# Office Action Summary

Application No.  
10/083,079

Applicant(s)  
SCHUTZ

Fig.3

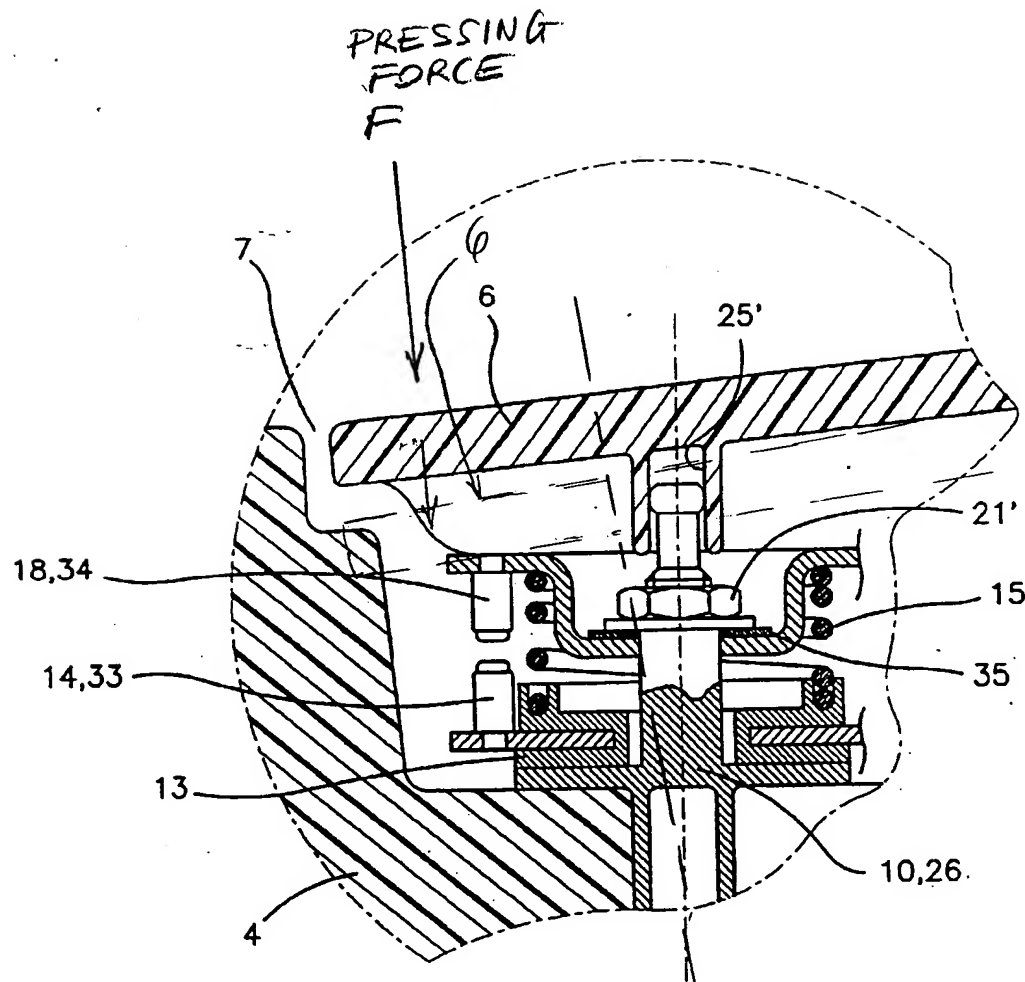
housing 17 having extensions 17 (Fig. 2, see Attachment) projecting laterally outwards and toward said edge 24 of said covering cap 6, said guides 10 or 10,26 being provided on said extensions 17.

movable/displaceable and parallel to the axis for actuating Bohn's horn contacts 14 and 18 (Fig. 3). When a driver presses or pushes Bohn's cover cap 6 down, Bohn's cap 6 is moved downwardly, consequently, Bohn's guides 10 or 10,26 is moved downwardly to make Bohn's switch 18 in contact with Bohn's switch 14 to actuate the horn as shown in Bohn's Fig. 3. Since Bohn's casing 6 is made of foam, thus, it is flexible and since Bohn's casing 6 and guides 10,26 are integrally connected together as transparently shown in Fig. 3, thus, if the driver applies his/her pressing force F (see Attachment) at a region of the outer edge of Bohn's casing 6, the casing 6 is inherently flexed or tilted downwardly, hence, the guide 10,26 is tilted therewith. In summary, Bohn implicitly discloses applicant's claimed functional language.

As seen in the above quoted argument, applicant expressly admits that Bohn's mounting plate 30 and mounting tab 17 may be tilted to actuate the horn switch 18, 14 as seen in Fig. 3. However, applicant concludes that the clearance space created by through hole 20 between the mounting tab 17 and the mounting stud 10 precludes any transfer of movement from the tab 17 to the stud 10. This assertion overlooks the fact that the upper part of the stud 10 is located within the guide recess 25' of the casing 6. Since the movement of the casing 6 is transmitted to the stud 10 via the guides 25', the stud 10 of Bohn is tilted when the casing 6 is tilted during actuation of the horn switch. In
